18 December 2018

Savills Project Management Pty Ltd
ABN 59 129 012 700

SSDA Application Number: SSD16_8114
Lindfield Learning Village – Condition B13 Landscape Management Plan_Rev 1e

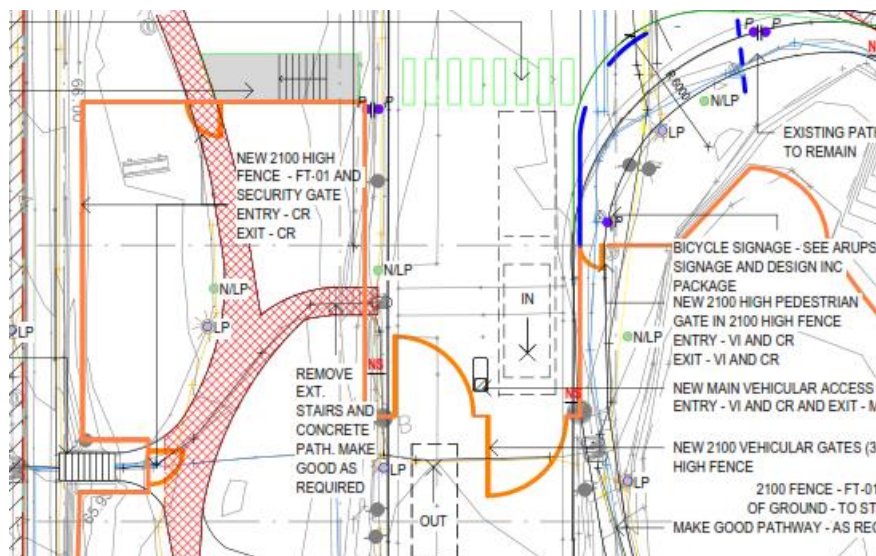
1. e) Figure 2 shows that most of the site is covered by the red line (study area). Why is the area in the centre of the figure below the sporting field excluded?
2. h) provide detail about which areas are required to be terraced?
3. k) Are only 4 species listed in LA-T-1000 to be used in landscaping on site?
4. l) section 4.1 is incomplete and missing information to be collected at each monitoring event.
5. m) details of fencing are not provided.
6. Pg 7 – states all trees would be retained in the IPA Heritage Zone. Table 2 page 20 allows for trees within the heritage zone to be removed at ground level. The management of trees in the Heritage zone needs to be clarified and consistent.
7. Appendix 1 – tree survey has a lot of trees listed as N/A under the retain column. What does this mean or relate to?

Condition #	DPE Comment
B13 Landscape Management Plan	Documentation received and to be reviewed by DPE. Further information required: <ul style="list-style-type: none"> • Landscape plans showing the fencing details and all of the requirements as stated by Condition B13.

1. e) Figure 2 in LMP has been amended to include the gymnasium building.
2. h) No terracing to slopes greater than 18 degrees is anticipated at this time and hence has not been shown on the plans. This will be reconfirmed at completion of vegetation works and the commencement of the maintenance of the APZ and included in the requirement at Condition D16.
3. k) Yes, only the 4 species listed in LA-T-1000 will be used on the landscaping on site.
4. l). Appendix 4 of the LMP has been updated to include a monitoring data sheet.
5. m) Refer DesignInc External Works Plan AR-T-1040 to AR AR-T 1047 and EFSG fence specification will be used for design specification guidelines.
6. There are no IPA heritage zones on site, reference has been removed in 12 November 2018 revised LMP.
7. This was a typo, reference has been removed in revised 12 November 2018 LMP.

Issued under B13 were AR-T-1040 to AR-T-1047 which show the fence line and have the following key to indicate the same.
